Our Ref: **16835 - Let 2**

20 February 2018

RE: TREE ISSUES AT 'VILLA MARIA', CAMPBELL ROAD, BOGNOR REGIS

Photograph 1 – Floor slab of existing building

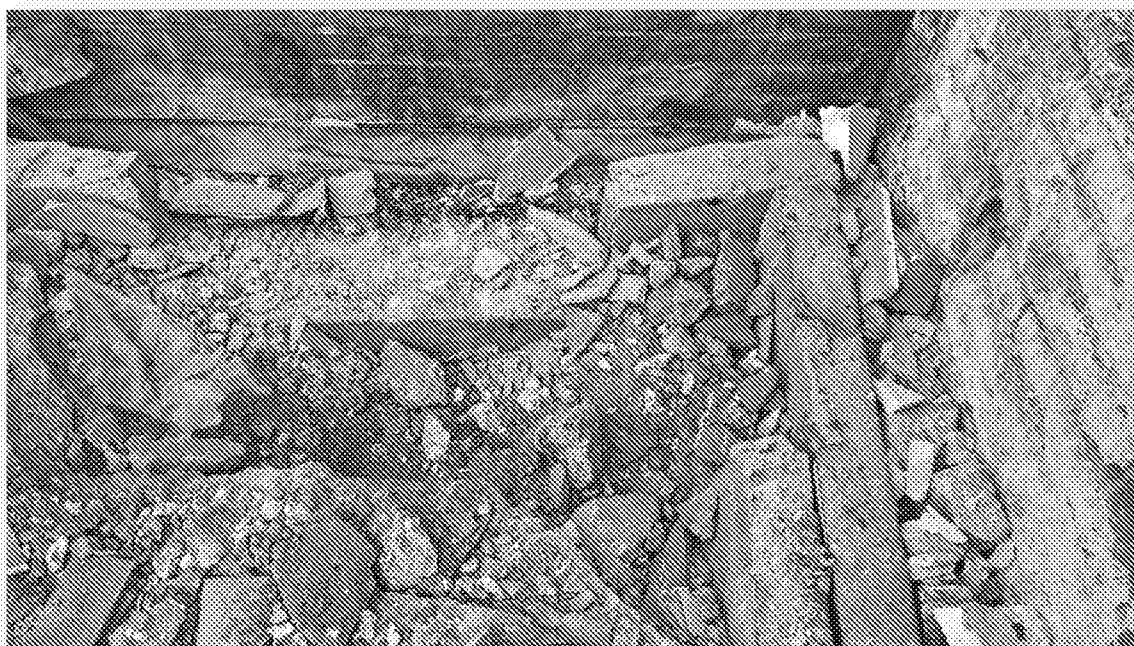
The floor slab of the existing building (photograph 1) in the north western corner of the site (and closest to the offsite trees) was carefully removed. It was noted that the boundary wall positioned between the trees and the site extended well below ground level and this was seated on an existing deep footing. The existing building foundation was located immediately adjacent to this and internally to the east and south of the wall. I can confirm that our exploratory investigations found no tree root activity (photographs 2, 3 and 4) to a depth of approximately 500mm in the vicinity of where the new studio accommodation was to be constructed. We determined that the position of the wall, the existing building foundations and the depth of their construction was the likely cause of the lack of root growth from the nearby trees into the site.

As a precautionary measure, we agreed that the existing building foundations were to be left in place, with the slab removed and replaced with beam and block flooring with a clear void beneath. Any new foundations

were to be cast outside the perimeter of the old, so as to avoid unnecessary ground disturbance internal to the existing perimeter building foundation.
